ILLUSTRATIVE SITE DESIGNS
FOR
MULTI-FAMILY HOUSING IN PASADENA

Prepared for the Pasadena
Multi-Family Housing Task Force

Daniel Solomon and Associates
Daniel Solomon
Kathryn Clarke
Susan Haviland

DSA 48.15

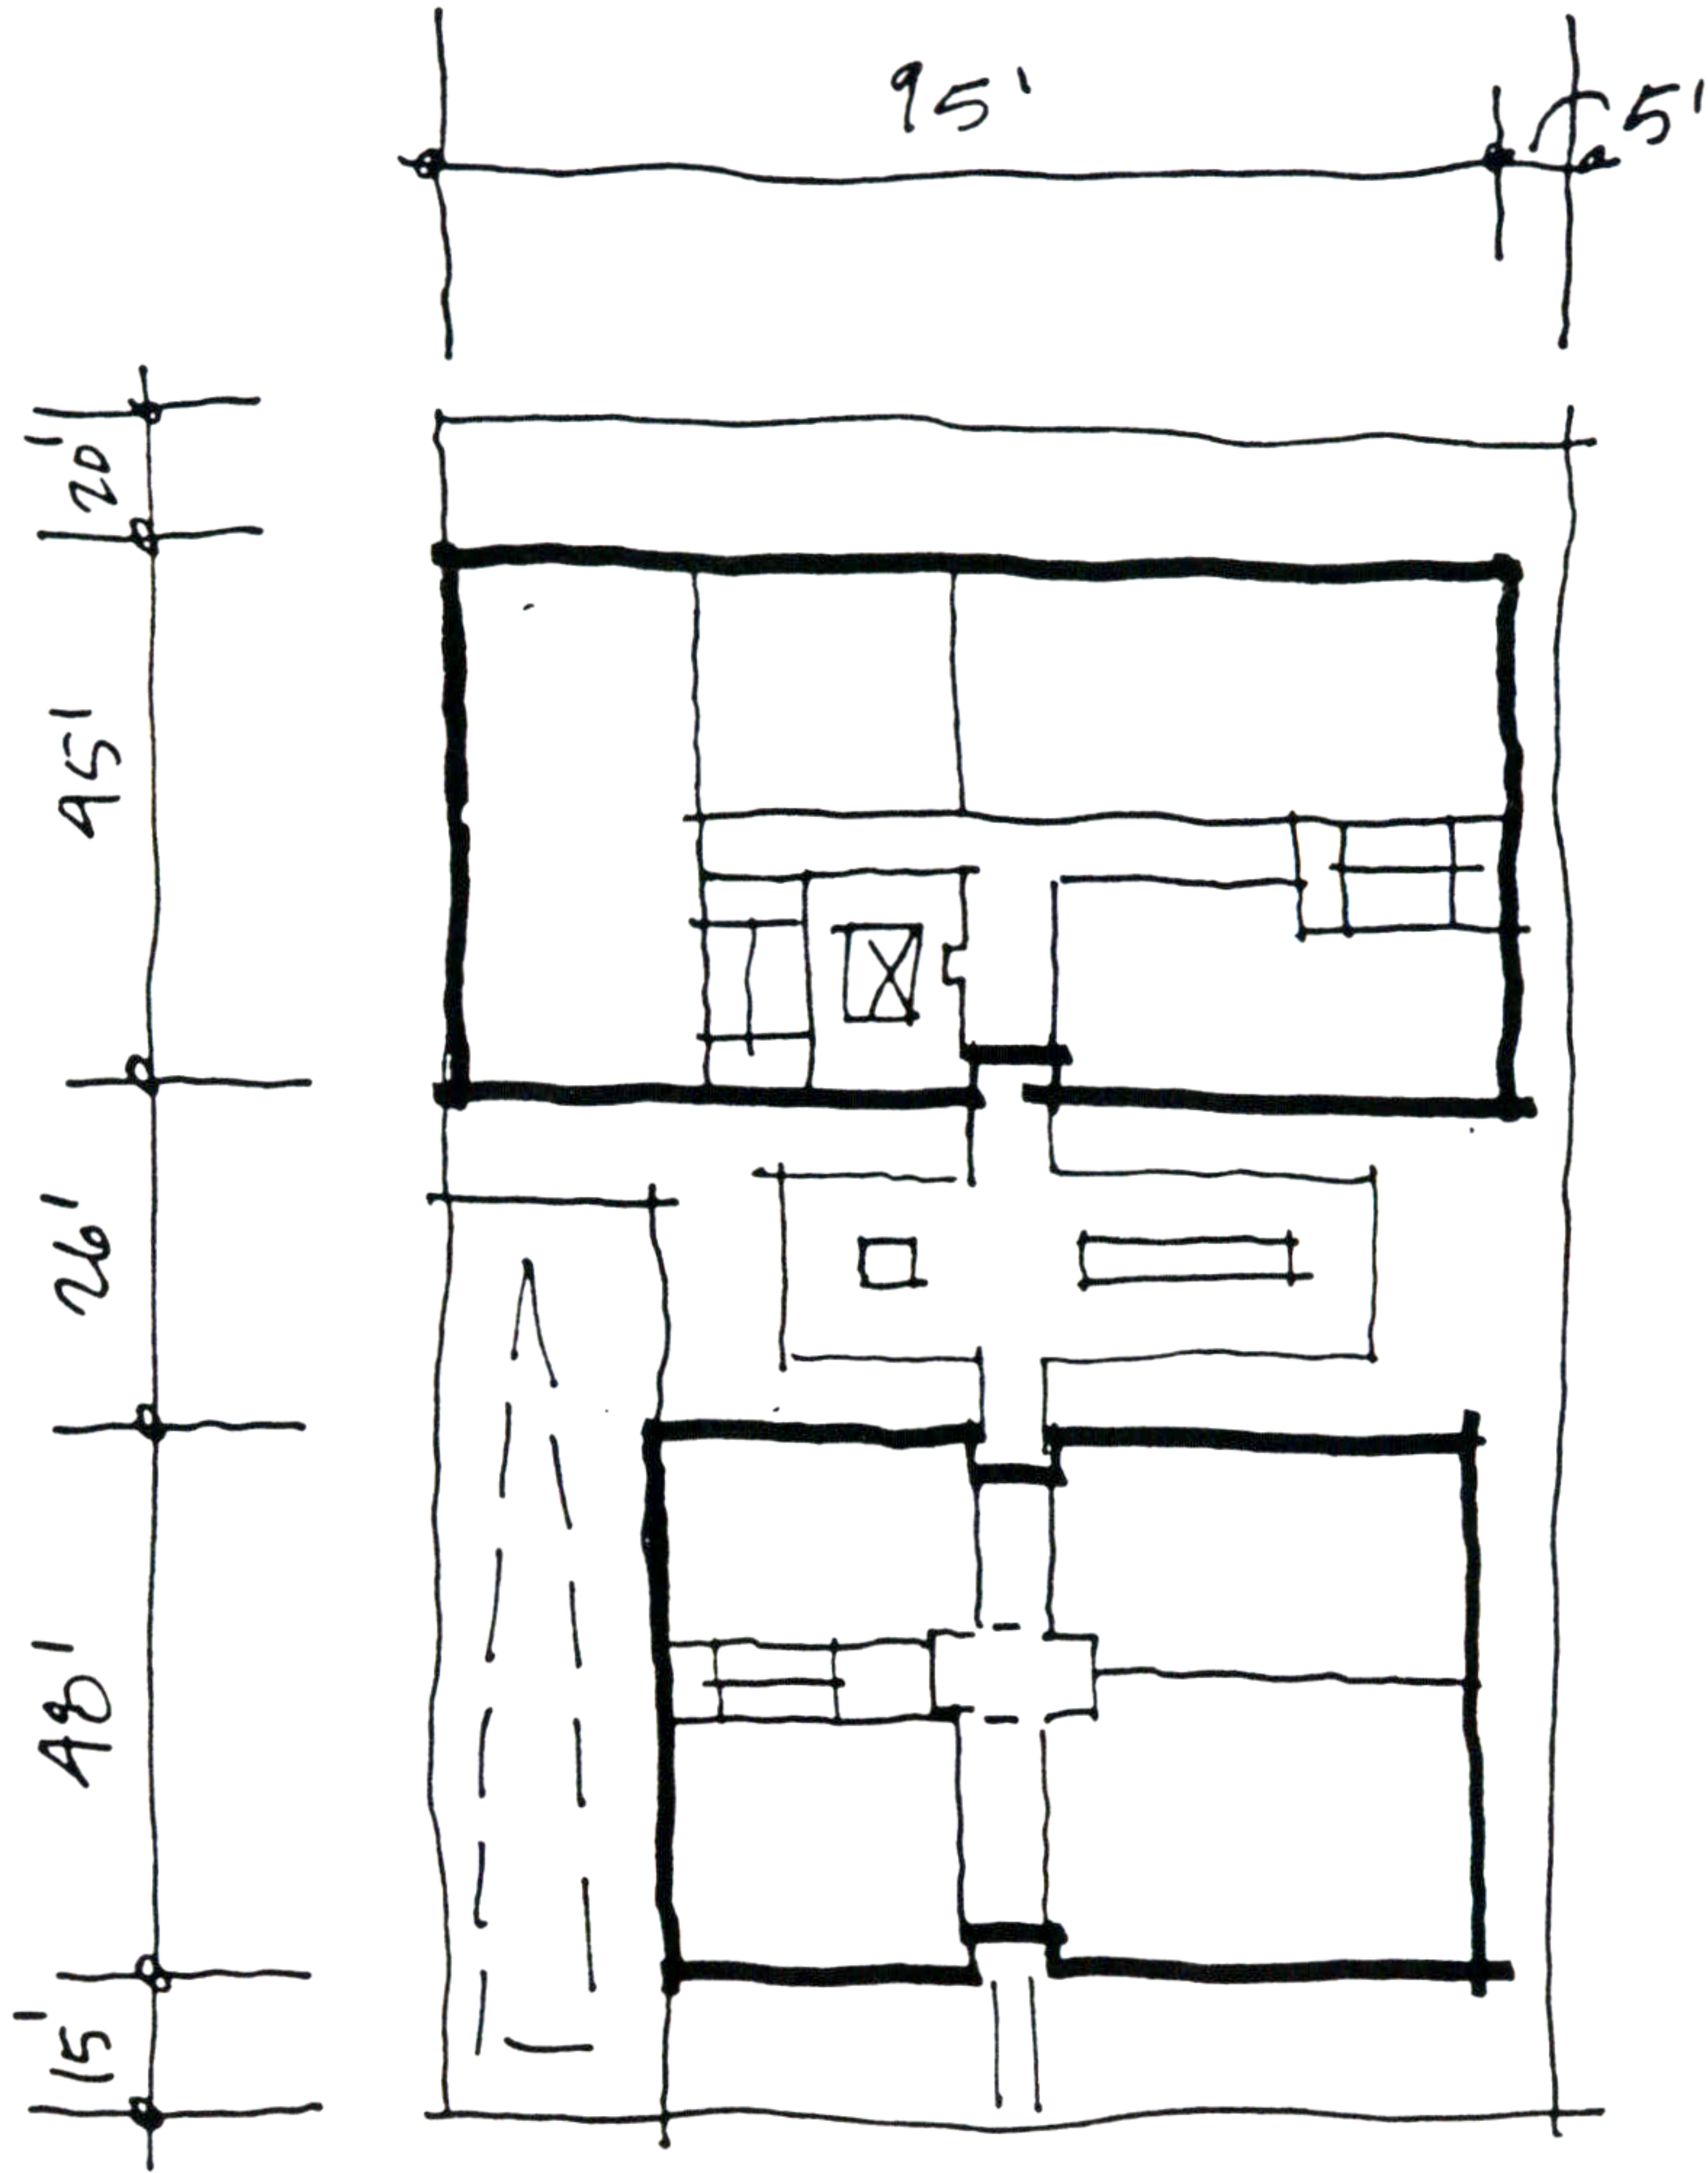
NO NUMBERS GIVEN!
